Access Compliance Report
Public Rights-of-Way
(Curb Ramps)

Intersection ID: N/A | **Main Street:** FREEDOM_DR | **Cross Street:** S_I-85_RA | **Location:** S

ADA ID: 08F4AD2832A2 | **Ramp Type:** BlendTrans1 | **Initial Pass/Fail:** Pass | **Overall Compliance:** No | **Severity Score:** 10.25

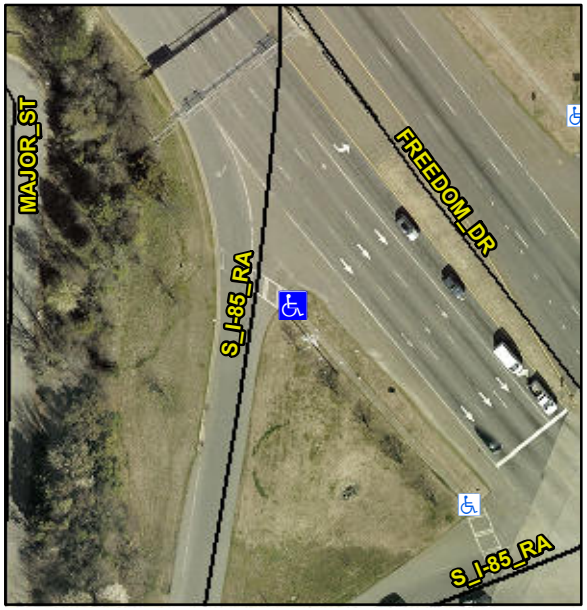
LOCATED ON ISLAND

R305

Install Detectable Warning System.
